**Department of Energy**  
Carlsbad Field Office  
P. O. Box 3090  
Carlsbad, New Mexico 88221

**Subject:** Response 2 to the U.S. Environmental Protection Agency's  
Questions on the Replacement Panels Planned Change Request  
dated April 17, 2024, April 24, 2024, and May 10, 2024, from Tom  
Peake to Michael Gerle

### **Department of Energy Response 2 to EPA's Questions on the RPPCR**

**Figure 1. RPPCR1-PROPMIC-1: Mean Total Mobile Concentration Through Time (Figure 11 from King and Wilgus, 2024. Pg 12)**

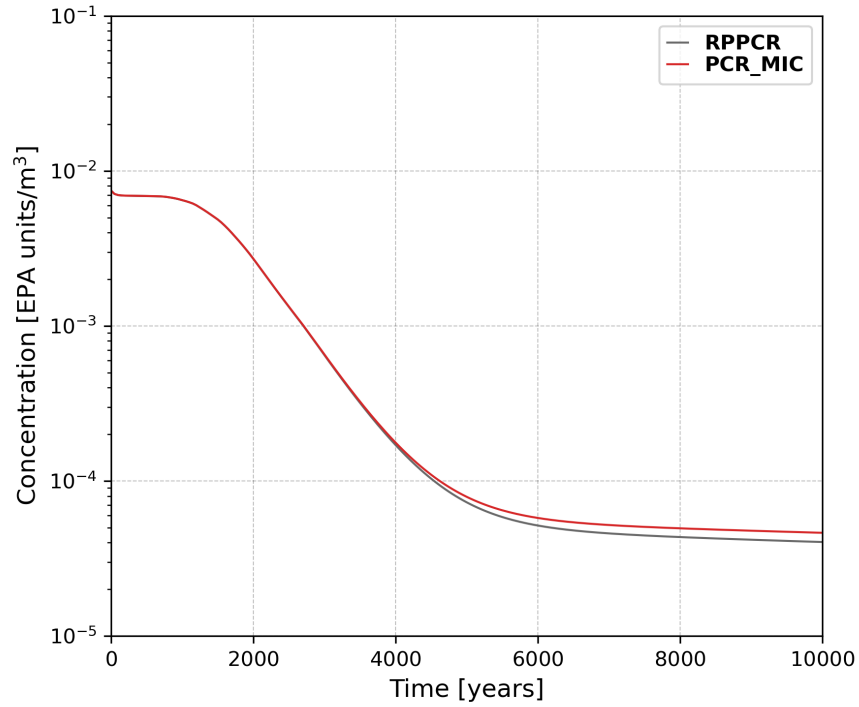
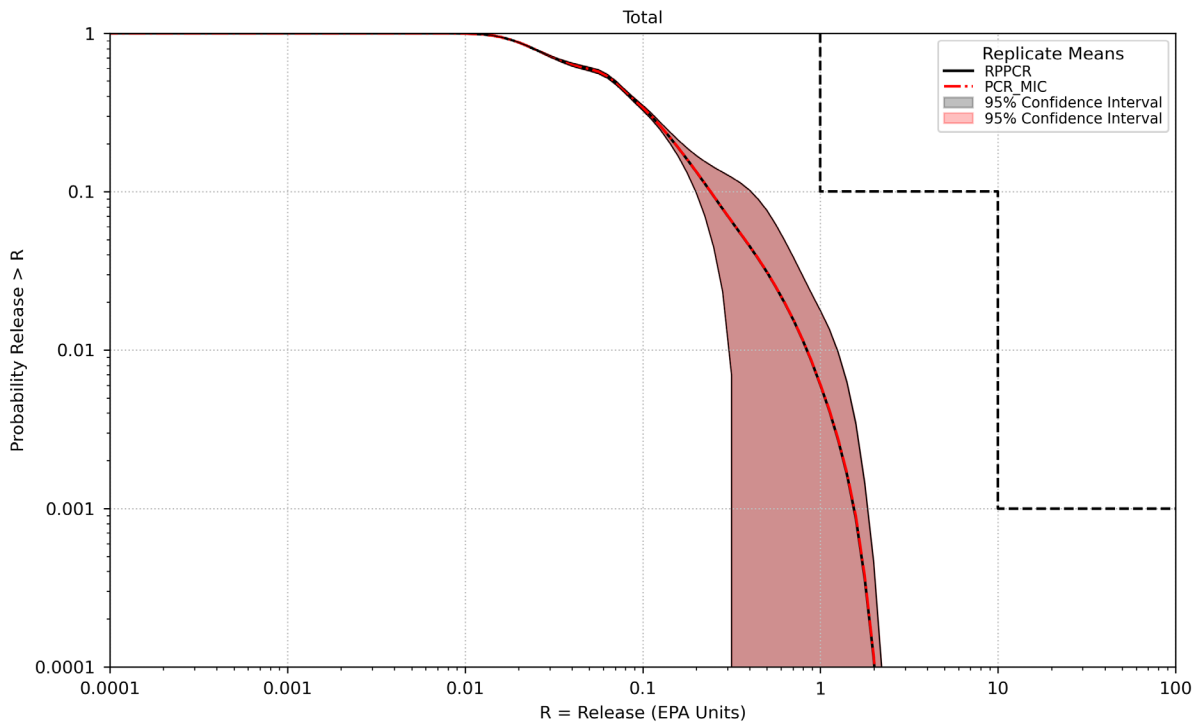
Please provide a quantitative assessment on how releases are impacted if the recommended Pu(III) values from Swanson and Lucchini (2023) are utilized for PA vectors that showed only Pu(III) releases. Lucchini and Swanson (2023) recommend a PROPMIC and CAPMIC value of 3.52 and  $9.00 \times 10^{-7}$  M, respectively, for Pu(III). Their recommended values for Pu(IV) are 0.3 and  $1.22 \times 10^{-9}$  M, respectively, and are also the values chosen for all Pu microbial colloids in the RPPCR (Table 4-20 of Brunnell et al. 2023).

The current microbial colloids approach in the PA is that colloid parameter values are element-specific. However, the values that have been recommended in Lucchini and Swanson (2023) also provide oxidation state specific Pu PROPMIC and CAPMIC parameters. Consequently, the RPPCR PA does not utilize a bounding Pu(III) microbial colloids parameter value and could be underestimating releases.

The RPPCR PA used the Pu(IV) values for the element-specific Pu microbial colloid parameters as the Pu(IV) state is more likely to be realized in the RPPCR PA calculations. DOE believes these are the most realistic values to use given the element-specific parameter implementation in the PA model. King and Wilgus (2024) performed the quantitative assessment requested for the sensitivity to releases when using the Pu(III) microbial colloid parameter values for vectors that realize the low oxidation state of plutonium. The sensitivity analysis done by King and Wilgus (2024) includes one new PA calculation named PCR\_MIC, based on the RPPCR PA. The only change from the RPPCR in PCR\_MIC is the adjustment of plutonium microbial colloid parameter values for vectors that realize the Pu(III) oxidation state. King and Wilgus (2024) compare results from PCR\_MIC to the RPPCR to demonstrate sensitivity. The results are described in detail in King and Wilgus (2024) and are summarized below.

The PCR\_MIC results for Salado flow and direct release volumes are qualitatively indistinguishable from the RPPCR. Slight differences in distribution and values of mobile concentrations occur between the RPPCR and PCR\_MIC with the most discernable difference being an increase of mean total mobile concentration in PCR\_MIC at times past approximately 4,000 years after repository closure (Figure 1 [Figure 11 of King and Wilgus, recreated below]). Accordingly, differences in releases between PCR\_MIC and the RPPCR are numerically small, demonstrating negligible sensitivity to the oxidation state-specific microbial colloid parameter values (Figure 2 and Table 1 [Figure 22 and Table 8 of King and Wilgus, recreated below]).

**Figure 4. RPPCR2-12PanelAnalyses: Total Mean Releases by Panel for Replicate 1 of the RPPCR (Figure 3 of Hansen et al. 2023a)**

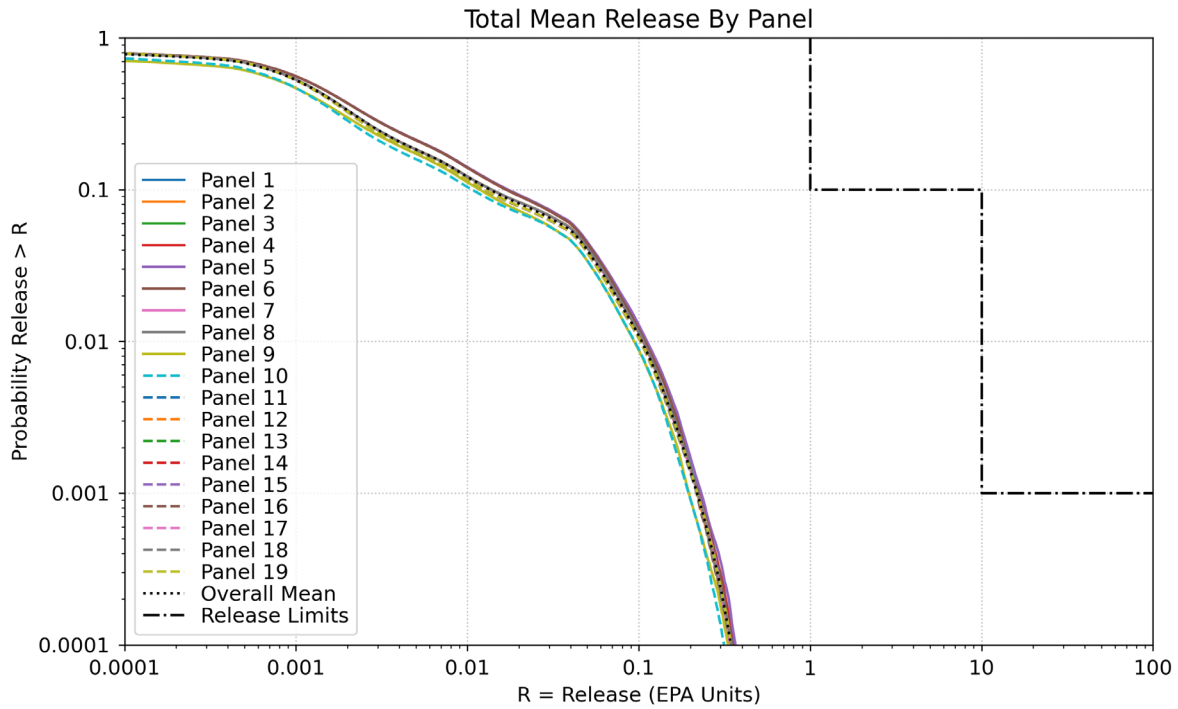
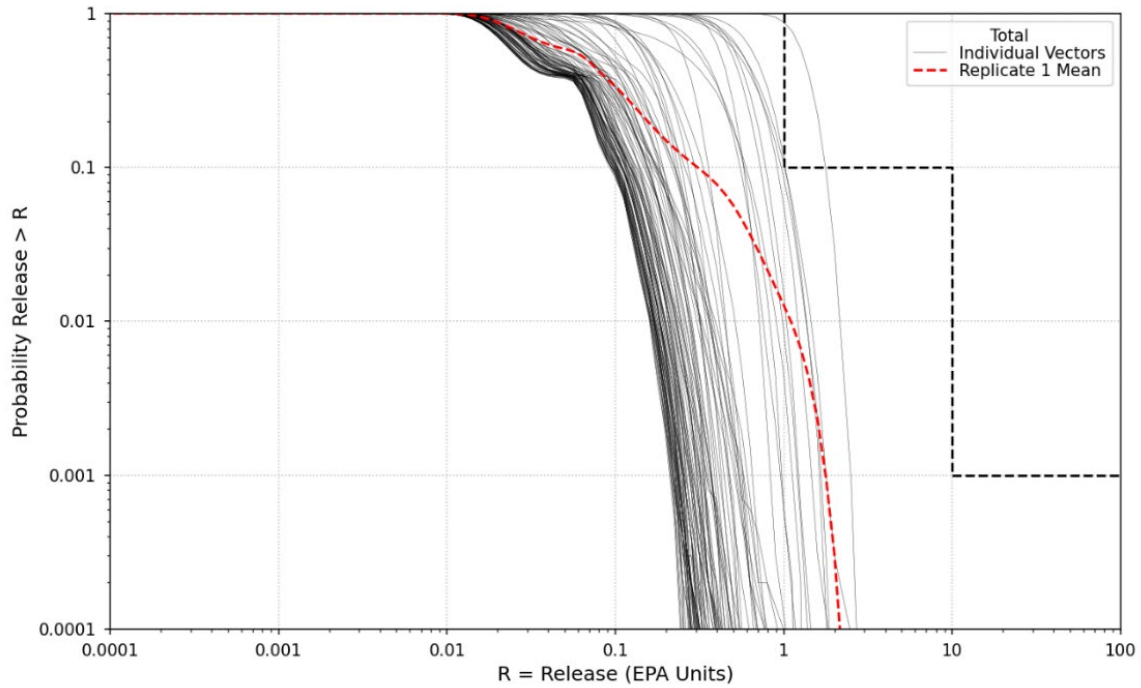
EPA is interested in the possibility of using the individual panel releases shown in Figure 3 of ERMS 580656 Estimation of Releases from a 12-Panel Repository by Hansen et al. (2023) to estimate releases from a 12-panel repository. We have the following two questions:

1. Please provide a detailed explanation of how the individual panel releases shown in Figure 3 of ERMS 580656 were calculated, with accompanying conceptual descriptions and justifications.
2. Please provide an explanation of how the individual panel releases shown in Figure 3 of ERMS 580656 accumulate to yield the combined releases of all 19 panels shown in Figure 4-43 of ERMS 581044 (the RPPCR PA).

- Figure 4 below (Figure 3 of Hansen et al., 2023a) shows the mean CCDFs of total releases attributable to individual panels. Figure 5 below (Figure 4-43 of Brunell et al., 2023) shows CCDFs for each realization of total releases from the repository. A total release from the repository is the sum of releases attributable to each panel, but the CCDFs in Figure 4 below cannot be added in a manner to obtain the mean CCDF in Figure 5 below.

In the PA calculation, random futures are simulated. Each random future comprises a sequence of intrusion events (and possibly a mining event); releases from each intrusion can be attributed to the intruded panel. The releases attributed to one panel can be summed to a total release for that future and panel. The total releases can be sorted in increasing order to form a CCDF and a mean CCDF computed over all realizations. This process produces the mean CCDFs in Figure 4 below.

A total release from the repository is computed by summing, for one future, all releases from intrusions into any panel. At this point, the total release is a sum of releases attributable to individual panels. However, after the panel releases (or the total releases) are sorted to form a CCDF, the identification of a release with a future is lost. As a consequence, at a given probability, the releases from different panels, and the total release, may be from different futures. Thus, the per-panel CCDFs cannot be “added” to obtain the CCDF of total releases.

Figure 7. RPPCR3-Closure-1 Stone and Argüello's predictions of vertical closure in Rooms 1 and 7 (Butcher and Mendenhall, 1993, pg. A-132)

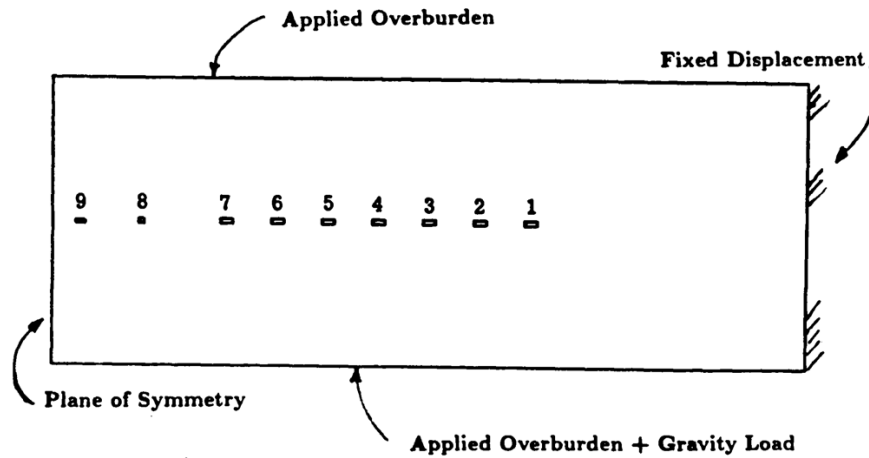
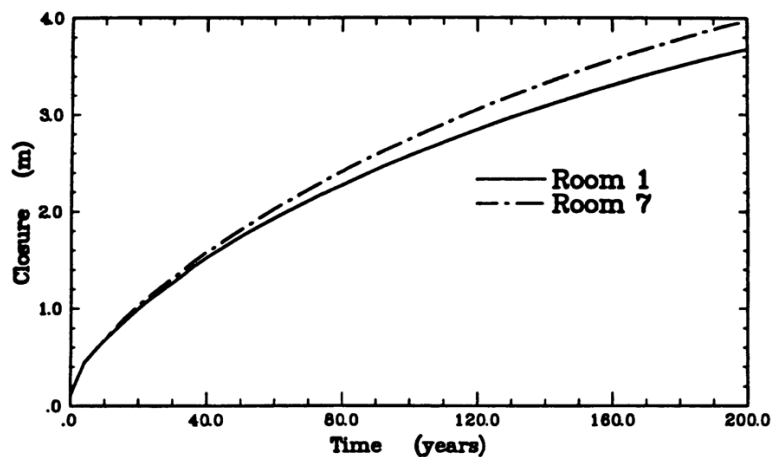
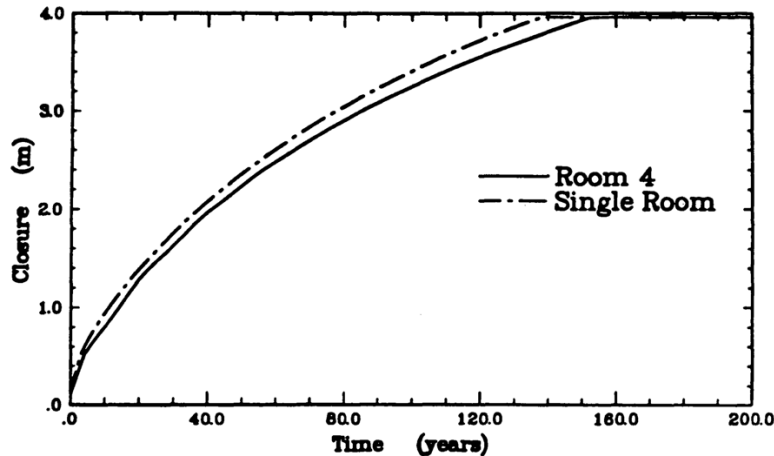
Please describe the effect of the room closure process with the new design used for RPPCR PA: the abutment pillars (between the waste rooms and the [main] access drifts) are increased from 61.0 m (200 ft) to 122.0 m (400 ft) and the isolation pillars (separating two panels) are increased from 61.0 m (200 ft) to 91.5 m (300 ft).

*EPA would like to know the effect of the new design on the waste-containing areas. Would this affect the timeframe of creep closure? Should this design change have any effect on the room closure, porosity, and gas generation relationship? Would this be reflected in the updated porosity surface?*

Previous simulations of room closure by Stone and Argüello (Butcher and Mendenhall, 1993, pg. A-121 to A-134) indicate that salt creep rate reductions related to wider abutment and isolation pillars will be small compared to other variations. Several aspects of the Stone and Argüello model differ from those in the current disposal room porosity model: their model does not include salt creep behavior at low stresses (< 8 MPa), salt transient creep behavior, the anhydrite layers, the clay seams, the waste, or gas trapped within the room. Nevertheless, the trends they found should be similar to the trends that would be predicted by the current disposal room porosity model, presuming the model differences do not strongly interact with the pillar width. As shown in Figure 6 below, one of the Stone and Argüello simulations included the seven rooms that make up a panel, as well as the two neighboring main access drifts. Room 1 was at the far-right end of the panel, adjacent to a practically infinite-width pillar, while Room 7 was to the right of the 61.0 m wide abutment pillar. Another of their simulations considered a single disposal room within an infinite array of parallel rooms. The vertical closure rates from these three cases are compared by averaging the vertical closure rate from time = 0 to the time the roof touches the floor in the fastest case, which is 140 years for the infinite array of parallel rooms. The Stone and Argüello model predicted that Room 1's average vertical closure rate would be 7 % less than that of Room 7. Doubling the width of the abutment pillar should, therefore, reduce the rate of room closure by less than 7 %. To put this 7 % in perspective, Stone and Argüello also predicted that Room 1's average vertical closure rate

would be 22 % less than that of the room in the infinite array (see Figure 7 and Figure 8 below). The legacy and current disposal room porosity models already neglect this 22 % reduction in closure rates by considering an infinite array of parallel disposal rooms (Stone, 1997, pg. 14; Vignes et al., 2023, Section 2.1.4), so a 7 % reduction is small. The Stone and Argüello model did not consider the effects of the isolation pillars between each panel, but it seems reasonable to expect that increasing their width should cause similar reductions in closure rates (< 7%) to the access drifts and parts of rooms close to these isolation pillars.

It should be noted that the pillar width does not impact the room's "final" porosity, which is reached once the resistance of the room contents balances the lithostatic pressure. Pillar width is only relevant while the room porosity is evolving. Room porosity evolves quickly if the lithostatic pressure exceeds the room contents' pressure by a large amount. In the Stone and Argüello model simulations of empty rooms and access drifts, the pressure difference was 14.8 MPa and each room reached 100 % vertical closure in 140 to 240 years, which is a small fraction of the 10,000-year regulatory period. Room porosity evolves more slowly, on the other hand, if the room contents supply a back pressure close to the lithostatic pressure, which occurs once the waste is compacted and fluids (gas or brine) cannot easily escape the room. Brown and Weatherby (Butcher and Mendenhall, 1993, pg. A-5 to A-25) included crushed salt, waste, and trapped gas in each room of their infinite array model and they predicted the room would approach its final porosity in the order of thousands of years. Regardless of the time required to reach the final porosity, doubling the pillar widths is still expected to reduce this time by less than 7 %.
